Product Change Notification - LIAL-14UBGG341

CCB 4068 Final Notice: Qualification of MTAI as an additional final test site for selected ATSAMD20G1xx Atmel device families available in 48L TQFP (7x7x1mm) package.

CCB 4068_ Packing Information Pre and Post Change Summary
PCN# LIAL-14UBGG341

Packing information -Tape and reel

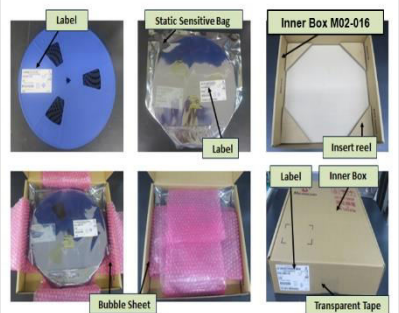
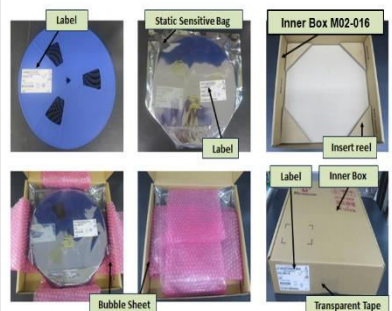
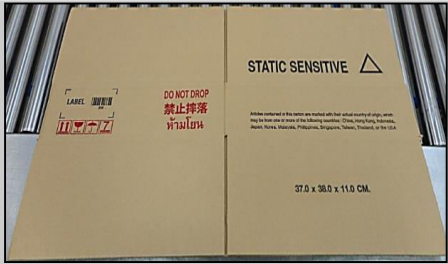
Pre-Change												Post Change					
Final Test Location	ASE9						MPHIL						MTAI					
Packing Media	Tape and Reel						Tape and Reel						Tape and Reel					
Base Quantity Multiple (BQM)	2500 units per reel						2500 units per reel						2500 units per reel					
Pin 1 Orientation	Quadrant 1						Quadrant 1						Quadrant 1					
Cove tape	Dimension:13.3mm, Heat Seal Adhesive						Dimension:13.3mm , Pressure Seal Adhesive						Dimension:13.3mm, Heat Seal Adhesive					
Carrier Tape	W	P1:	A0	B0	K0	K1:	W	P1:	A0	B0	K0	K1:	W	P1:	A0	B0	K0	K1:
	16 mm	12 mm	9.30 mm	9.30 mm	1.8 mm	1.2 mm	16 mm	12 mm	9.30 mm	9.30 mm	1.8 mm	1.2 mm	16 mm	12 mm	9.60 mm	9.60 mm	1.85 mm	1.25 mm

Packing information -Tape and reel

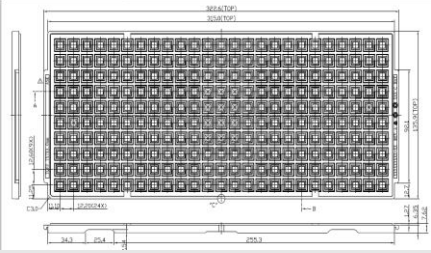
Pre-Change										Post Change				
Final test location	ASE9					MPHL					MTAI				
	Color	Diameter	Hub:	W1	W2	Color	Diameter	Hub:	W1	W2	Color	Diameter	Hub:	W1	W2
	WHITE	330	4 inch (100mm)	16.80 mm (+0.3/-0.2)	22.20 Max	WHITE	330	4 inch (100mm)	17.5 +/- 0.5	21.5 +/- 1.0	Dark Blue	330	4 inch (100mm)	16.40 mm (+2.00/-0.00)	22.20 Max
Reel															
Antistatic shielding bag															
	430 x 495 mm					406 x 457 mm					370 x 420 mm

Packing information -Tape and reel

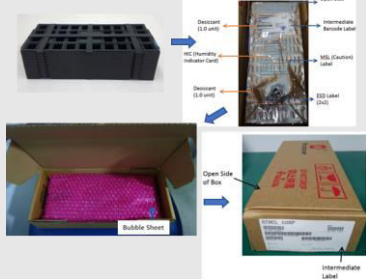
Pre-Change		Post Change
Final test location	ASE9	MPHL	MTAI
Packing Method	 <p>Inner box 37x35.3x7.7 cm</p>	 <p>Inner Box Reel 37x35.3x7.7 cm</p>	 <p>Inner Box Reel 37x35.3x7.7 cm</p>
Outer Carton Box)	 <p>36.5x38.4x10.4 cm (1 inner box per 1 outer box) 38.5x39.0x36.0 cm (4 inner box per 1 outer box) 38.5x66.0x40.5 cm (8 inner box per 1 outer box)</p>	 <p>37.0x38.0x11.0 cm (1 inner box per 1 outer box) 37.0x38.0x22.5 cm (2 inner box per 1 outer box) 37.0x39.0x39.0 cm (4 inner box per 1 outer box) 42.0x66.0x39.0 cm (8 inner box per 1 outer box)</p>	 <p>37.0x38.0x11.0 cm (1 inner box per 1 outer box) 37.0x38.0x22.5 cm (2 inner box per 1 outer box) 37.0x39.0x39.0 cm (4 inner box per 1 outer box) 28.6x37.5x36.2 cm (4 inner box per 1 outer box) 42.0x66.0x39.0 cm (8 inner box per 1 outer box)</p>
